CITY OF CONWAY, ARKANSAS HISTORIC DISTRICT COMMISSION

July 22, 2024 • 5:30pm • 1111 Main Street

City of Conway HISTORIC DISTRICT COMMISSION

July 22, 2024

1152 Hunter St-New Construction: Duplexes

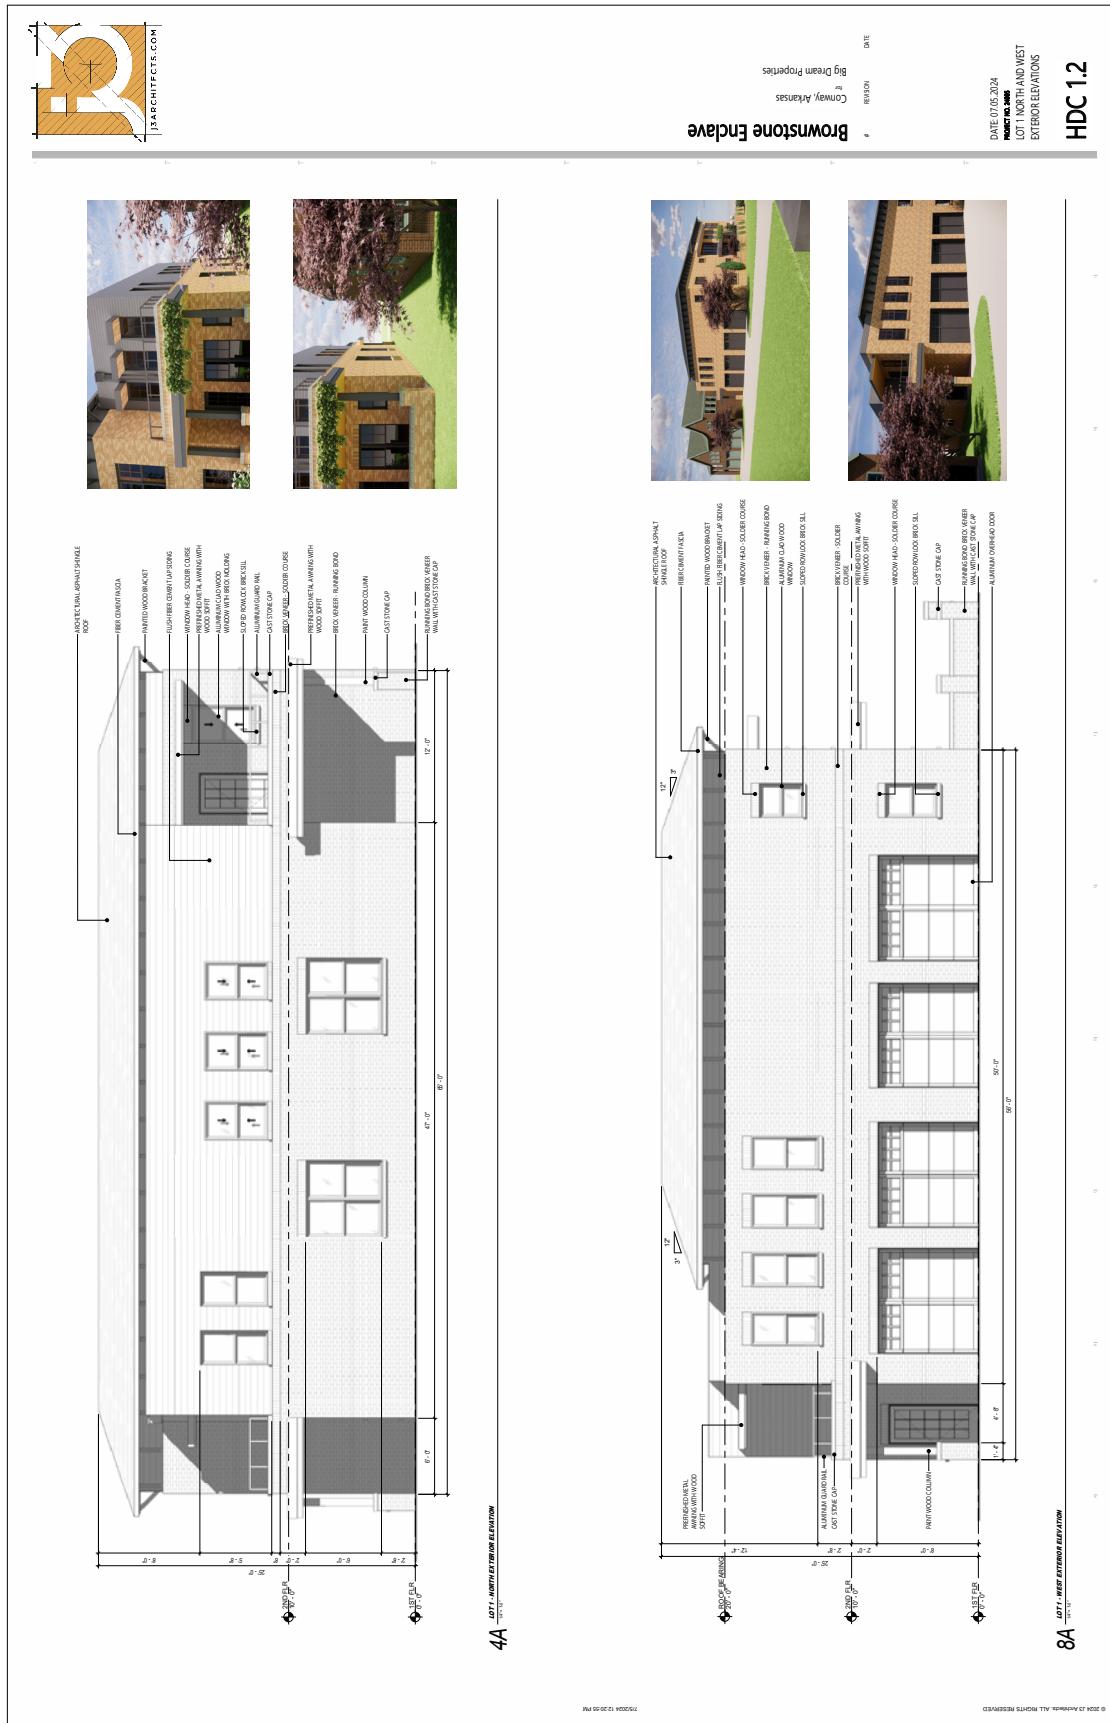
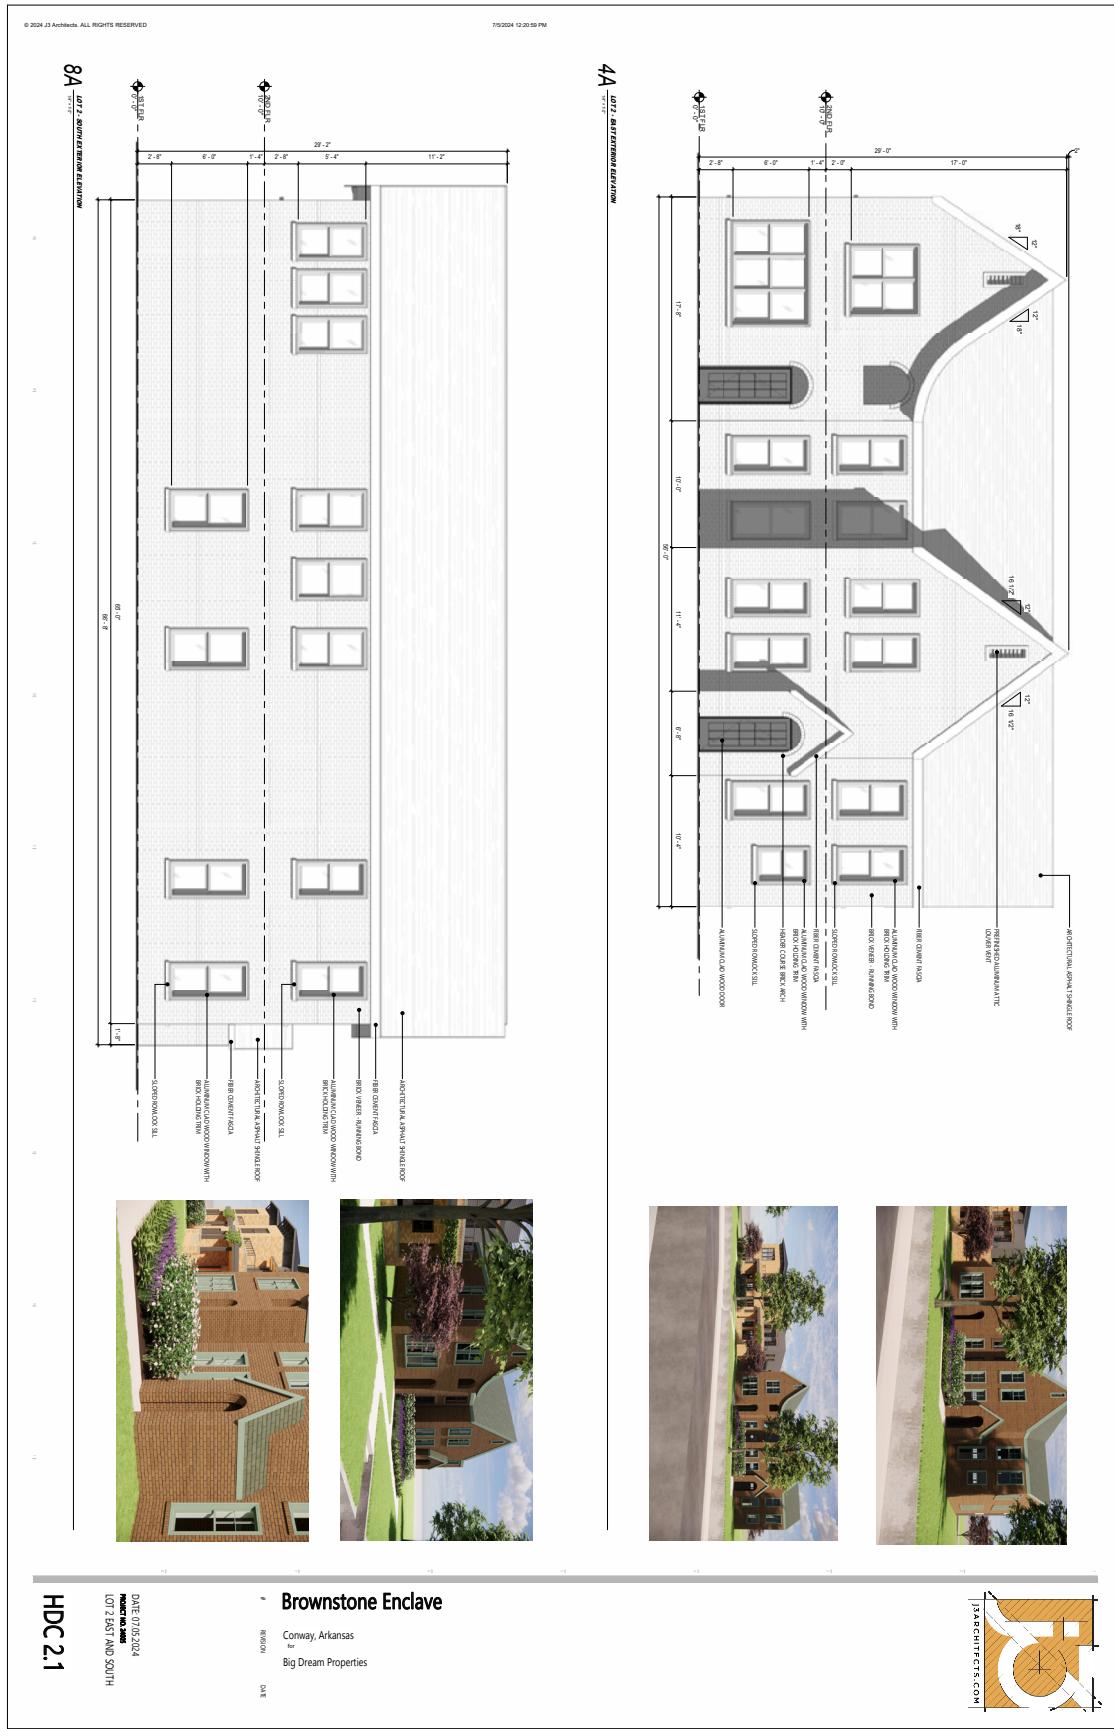
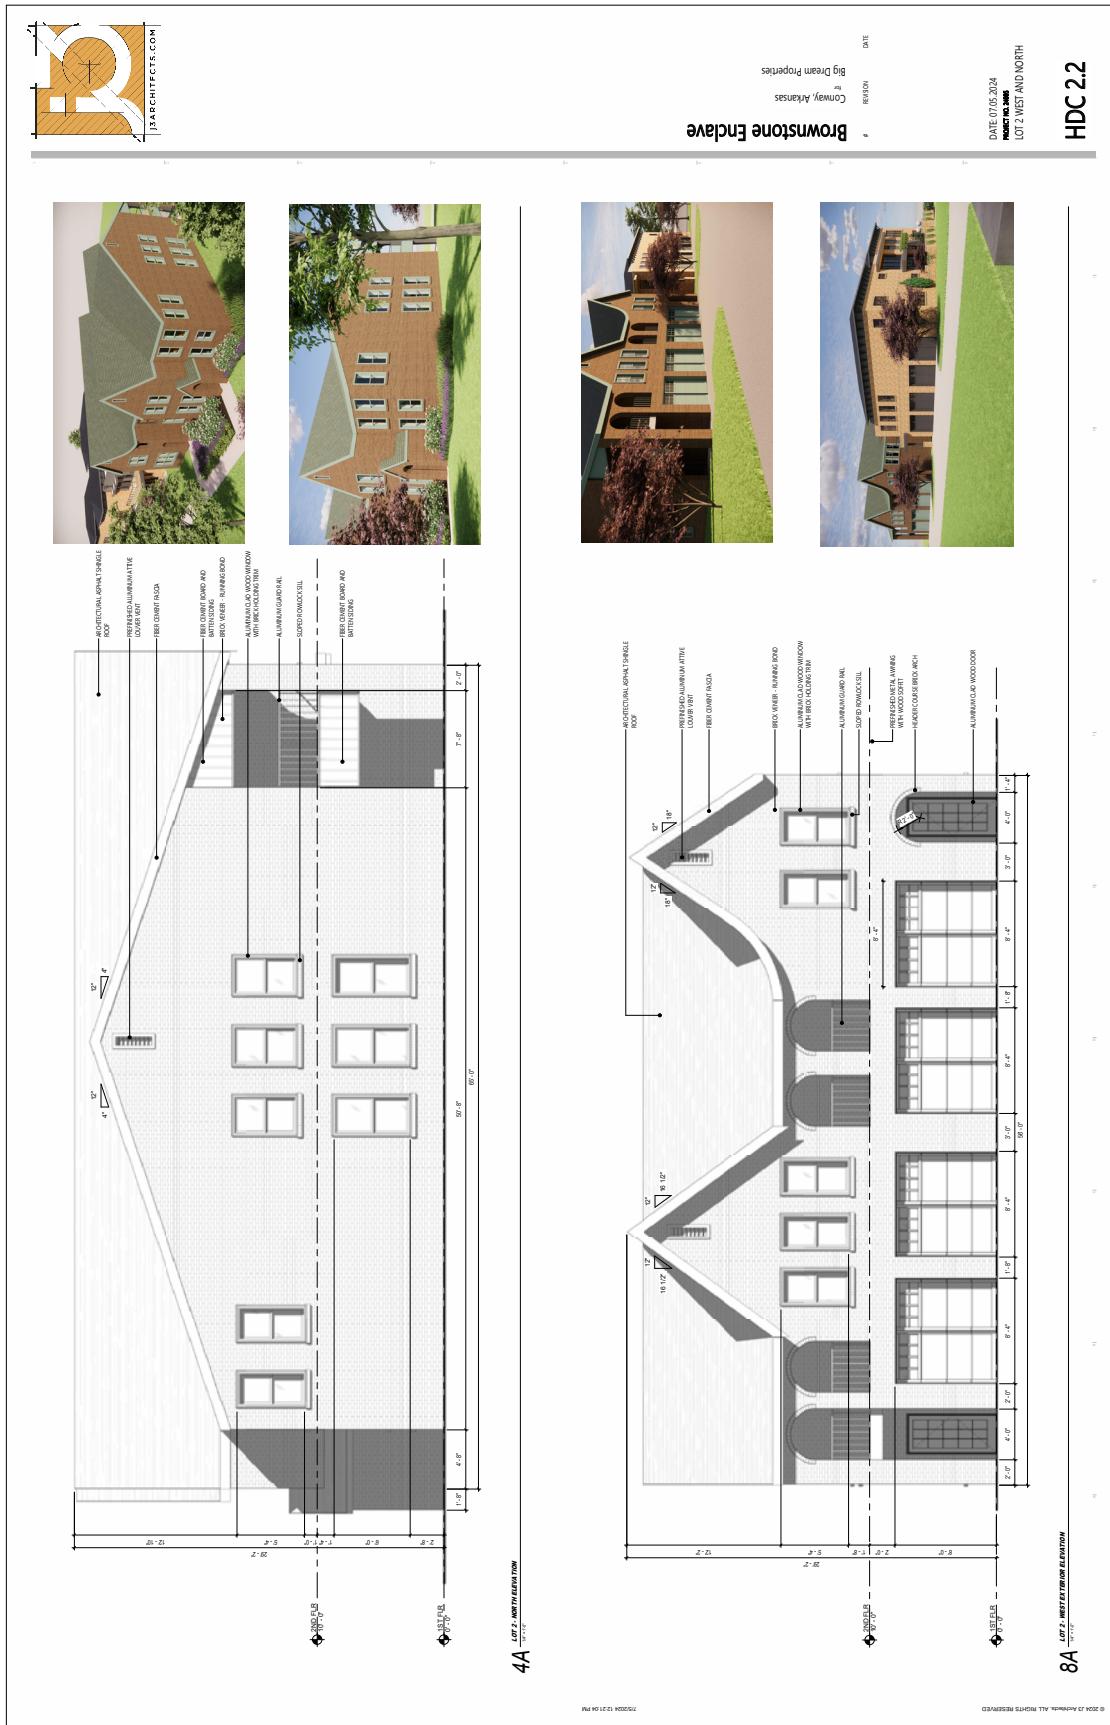
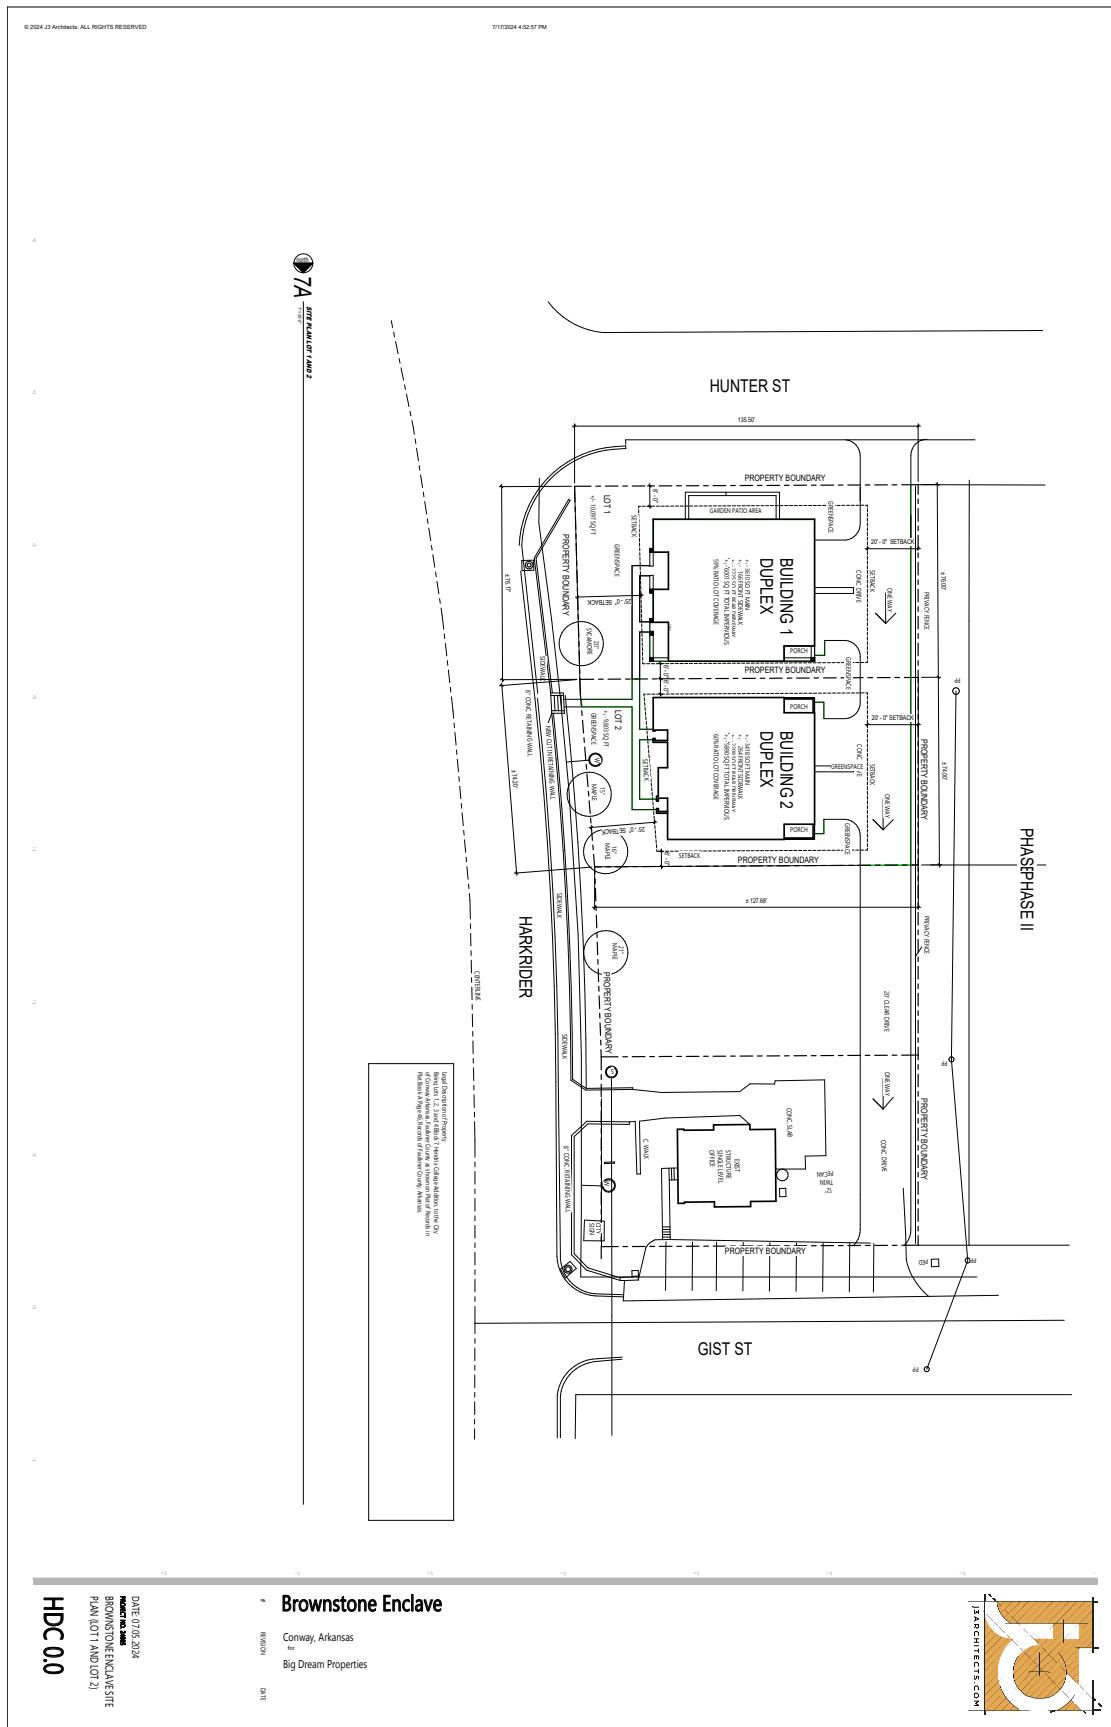
The average front setback for the area is 35 feet, based on four structures fronting Harkrider Street in the Hendrix College Addition. To meet the requirement the applicant would need to be between 29 feet and 40 feet. Staff measures setbacks in the area from aerial imagery which is not 100% accurate. The applicant is proposing a front setback of 25 feet. Given that aerial imagery measurements are not 100% accurate and that the applicant must accommodate a 20 feet driveway at the rear of the property, staff supports the 25-foot front setback.

A sidewalk is present on Harkrider St. The applicant is proposing a new cut in the retaining wall with a sidewalk leading to each unit. A sidewalk path from Hunter St is also proposed but no sidewalk in the right of way on Hunter St. There are no sidewalks along Hunter St between Harkrider and Cleveland Ave. Planning staff recommends construction of a 5' sidewalk with 6 1/2 feet of greenspace.

Each unit contains a front porch. Unit 1 has porches which are 6' deep. The depth of the front porches on Unit 2 are unclear but should be 6' deep. The porch supports, overhanging eaves and window boxes provide decorative elements on Unit 1. On Unit 2 the header course brick arches and gabled roof provide decorative elements on the porches. Windows are primarily one over one with some fixed windows along the southern elevation on Unit 1.

2. A landscape plan shall be submitted with the Site Development Review application which shows trees to be removed, trees to be retained and the species type to be planted as permitted by the OCDOD approved tree species list. Any tree removed will need to be replaced at a 1:1 ratio.
3. Significant trees to be retained must be protected through fencing.
4. Prior to issuance of a building permit, the lots will need to be platted.
5. The rear privacy fence shall be wood, stone, brick or a material approved by Planning Staff prior to installation. Chain link or barbed wire are not allowed.
6. The private access drive and driveways shall be concrete or permeable pavers.
7. A 5' sidewalk with 6.5' greenspace is required for the Hunter St frontage.
8. Lighting shall be downward and inward toward the property.
9. HVAC equipment shall be screened from public view.
